Certificate of Appropriateness for 2115 Kendall Ave.

September 16, 2019

Proposed Work

Window 4: Living room west-facing, approx. 28" by 61"

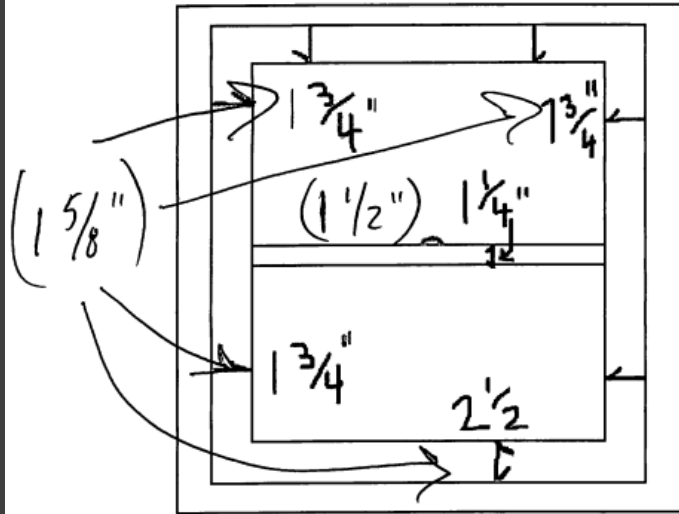
This window has significant paint chipping on the sill and external frame. Opens (doesn't stay open), but lock mechanism was altered and is unstable.

Replace with: similar dimension 28" by 61" double-hung Okna 500 series.

UPSTAIRS WINDOW DIMENSIONS 2115 Kendall Ave Madison WI 53726

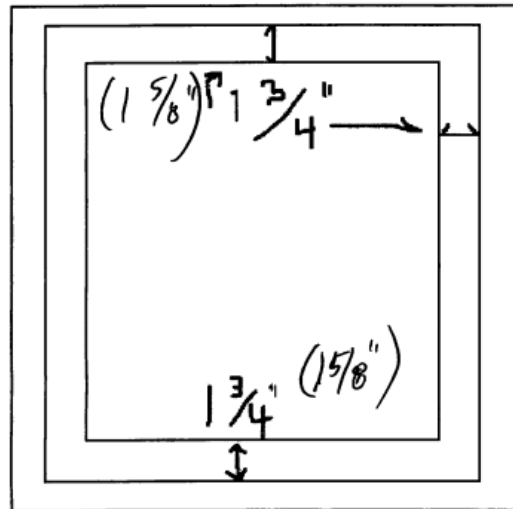
These measures are for upstairs windows 11, 12, 13, 14, 15, 16.

Frame measures for windows (as measured by Jordan Exteriors) are: 28" by 55"
